Project	IEEE 802.16 Broadband Wireless Access Working Group < http://ieee802.org/16 >	
Title	Corrections to STC transmission.	
Date Submitted	July 07, 2004	
Source(s)	Atul Salvekar, Ph.D. Baraa Al-Dabagh Hassan Yaghoobi, Ph.D.	mailto:atul.a.salvekar@intel.com mailto:baraa.al.dabagh@intel.com mailto:hassan.yaghoobi@intel.com
	Intel Corporation CHP3-105 350 East Plumeria Dr. San Jose, CA 95134	
Re:	Supporting document for recirculation ballot #14b.	
Abstract	<p>In P802.16 REVd/D5 [1], an STC Preamble is only mandatory if there is an STC allocation in the frame. However, in order to get accurate maintenance values, for example power, an STC preamble should occur in a preceding frame. In order to alleviate the situation, it is recommended that if there is an STC allocation in frame K and there is no STC allocation in the preceding frame, K-1, then the BS must transmit an STC preamble as the last allocation in the preceding frame, i.e frame K-1. A second recommended item is to adjust the STC FCH so that it mirrors the FCH in normal transmission. This resolves the problem in the current standard that the MAP cannot necessarily be parsed in STC mode. This issue becomes even more severe in

Figure 1: Instability caused by using a single STC preamble for STC data transmission.

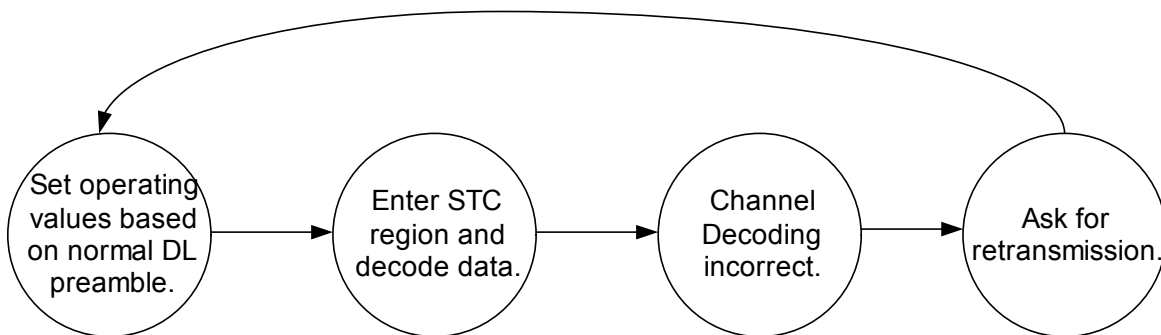
Suppose that during non-STC portions of the frame, the BS transmits on antenna 1. The SS sets operating values based on the DL preamble. Once STC enabled transmission begins, both antenna 1 and antenna 2 transmit, which may make these operating values faulty. This can result in incorrect decoding of the data. For instance the power from a single antenna could be over 20 dB less than that of a second antenna for uncorrelated Rayleigh Fading Channels. In this case, instability can exist as expressed in Figure 1.

Figure 2: New STC Frame structure in TDD

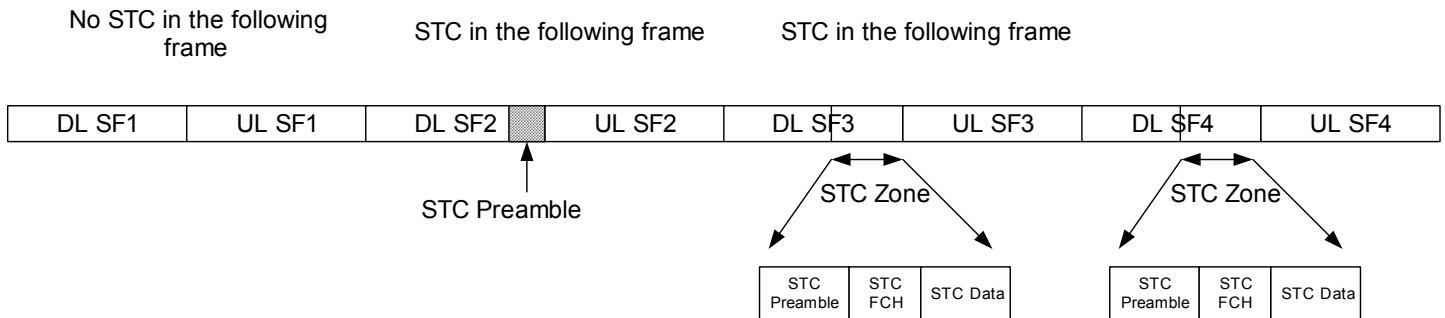
Thus, we suggest that in the case that there is STC encoded traffic in a specific frame, K, without STC encoded data traffic on the previous frame, K-1, the preceding BS DL subframe, K-1, shall contain an STC zone, in which the STC zone consists of only an STC preamble without FCH-STC. The SS will be able to determine that there is no FCH-STC by determining that the STC preamble is at the end of a frame. This is expressed in for TDD transmission in Figure 2. SF refers to subframe in the figure below.

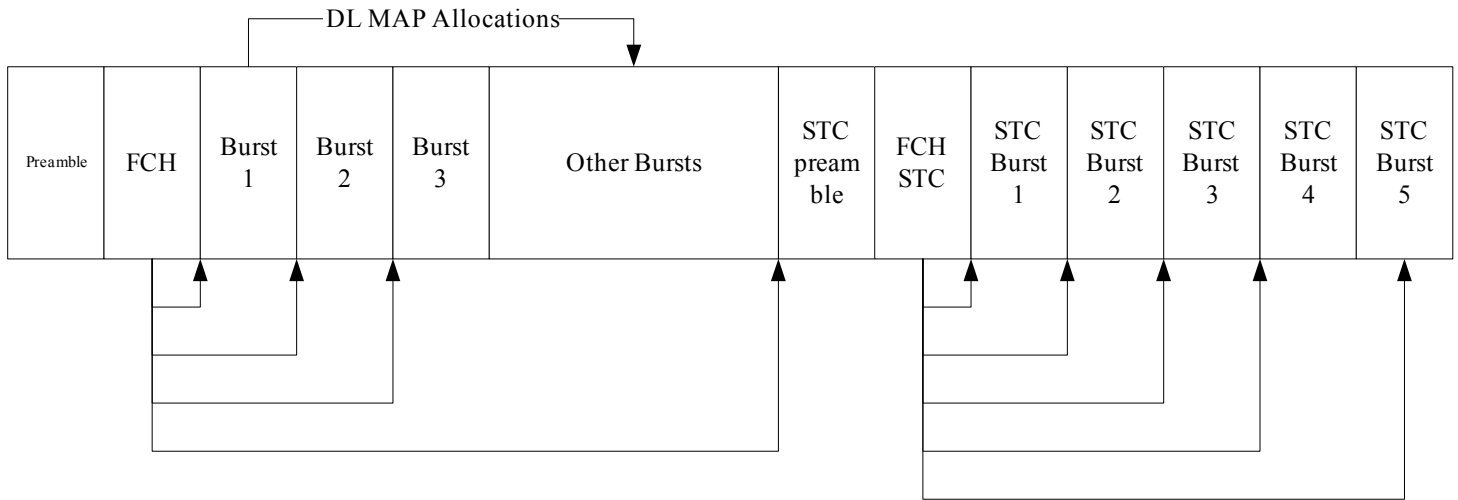
The STC zone starts from a preamble and an STC encoded FCH-STC burst, which is one symbol with the same payload format as specified in Table 239. The FCH-STC burst is transmitted at BPSK rate $\frac{1}{2}$. It is followed by one or several STC encoded PHY bursts. The first burst in the STC zone may contain a DL-MAP applicable only to the STC zone. If DL-MAP is present, it shall be the first MAC PDU in the payload of the burst.

In the case that there is STC encoded traffic in a specific frame, K, without STC encoded data traffic on the previous frame, K-1, the preceding BS DL subframe, K-1, shall contain an STC zone, in which the STC zone consists of only an STC preamble without FCH-STC. The SS will be able to determine that there is no FCH-STC by determining that the STC preamble is at the end of a frame.
